Planning Commission Staff Report

Subject: Ordinance Amendment Vote Report

Petition: P.Z. 25-2008 City of Chesterfield (Tree Preservation and Landscape Requirements)

Figure 1: Buffer Requirements

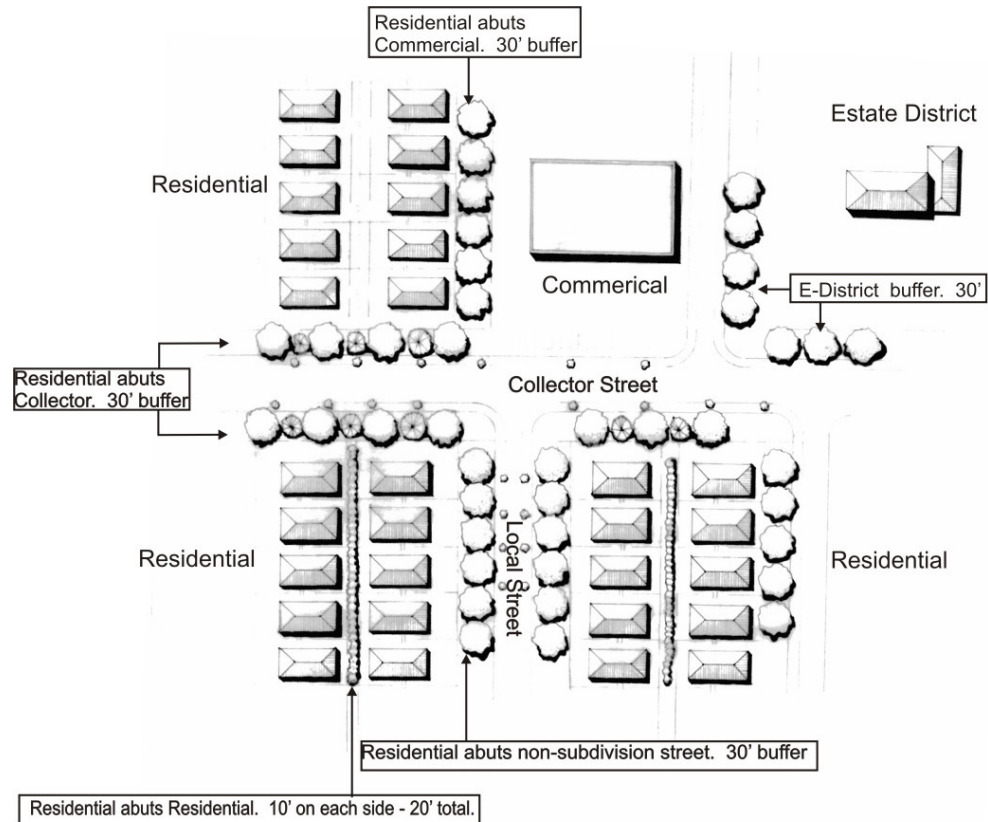
p.14, XI – Plant Selections, E – The requirement to utilize a variety of tree species in projects installing over 50 trees may be an additional expense not currently advisable to employ on the building industry.
